DART SERVICE INSTRUCTION

TO AMEND INSTALLATION INSTRUCTIONS D350-567 REV. E
AND INSTRUCTIONS FOR CONTINUED AIRWORTHINESS ICA-D350-567 REV. 2

REF. TCCA STC: SH92-18

A	NEW ISSUE (SEE PAR 16-510)	AJS	16.04.06
REV.	DESCRIPTION	BY	DATE
DESIGN	AJS	DART AEROSPACE LTD	
DRAWN	AJS	HAWKESBURY, ONTARIO, CANADA	
CHECKED		DRAWING NO.	REV. A
MFG. APPR.	N/A	DSI 9745	SHEET 1 OF 3
APPROVED		TITLE	SCALE
DE APPR.		ALTERNATE FIRE EX LOCATION	NTS
DATE	16.04.06	COPYRIGHT © 2016 BY DART AEROSPACE LTD THIS DOCUMENT IS PRIVATE AND CONFIDENTIAL AND IS SUPPLIED ON THE EXPRESS CONDITION THAT IT IS NOT TO BE USED FOR ANY PURPOSE OR COPIED OR COMMUNICATED TO ANY OTHER PERSON WITHOUT WRITTEN PERMISSION FROM DART AEROSPACE LTD.

FIGURE 1

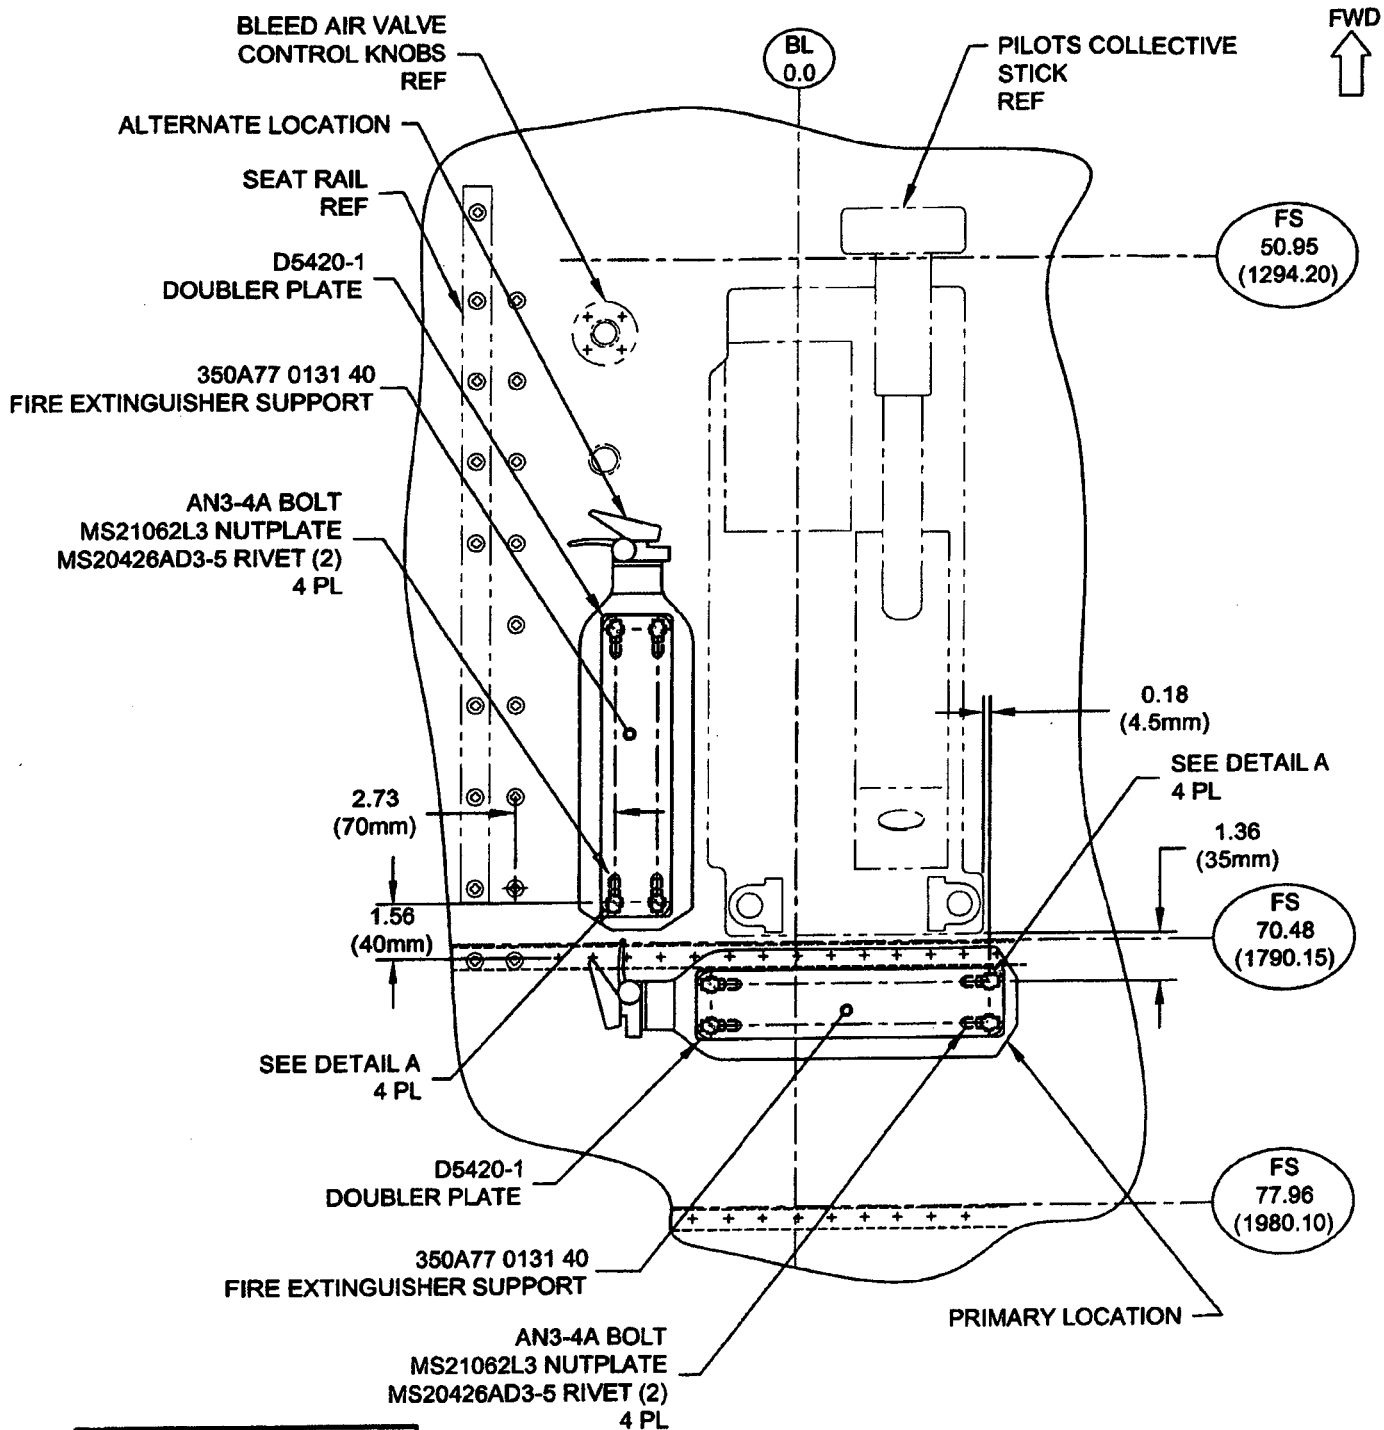
Remove and retain the cabin fire extinguisher P/N 1708337 B4 and Fire Extinguisher Support P/N 350A77 0131 40 from existing location. Per Figure 1, select the desired location for the fire extinguisher at either the "Primary" location or "Alternate" location.

Locate the D5420-1 Doubler Plate at the selected location per Figure 1 and transfer mark the holes from the D5420-1 Doubler Plate to the aircraft floor. Drill the nutplate hole pattern shown in Detail A. Touch up the drilled floor surface finish with chemical film (Alodine 1200/1201) per MIL-C-5541 and one coat of MIL-P-85582 or MIL-P-23377 primer.
